World Forum for Harmonization of Vehicle Regulations

Proposal for a new 07 series of amendments to UN Regulation No. 49 (Emissions of compression ignition and positive ignition (LPG and CNG) engines)

Submitted by the Working Party on Pollution and Energy*

Example of a PM number analyser setup

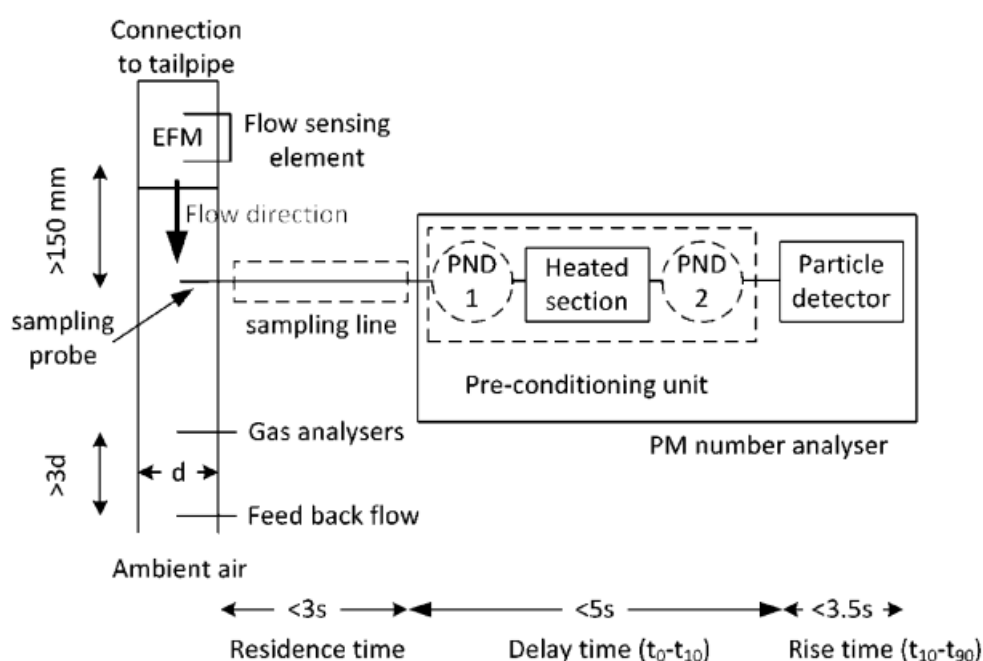
Add a new paragraph A.2.2.5., to read:

A.2.2.5.1.1. The PM number analyser shall consist of a pre-conditioning unit and a particle detector (see Figure 1). The particle detector may also pre-condition the aerosol. The analyser's sensitivity to shocks, vibrations, aging, variations in temperature and air pressure, electromagnetic interferences and other things that could affect the operation of the vehicle or the analyser shall be kept to a minimum as far as possible and shall be clearly stated in the supporting documentation produced by the instrument manufacturer. The PM number analyser shall fulfil the requirements of this Regulation and the specifications of the instrument manufacturer.

Notes: dotted lines depict optional parts; EFM means Exhaust mass Flow Meter; d means inner diameter ; PND means PM Number Diluter
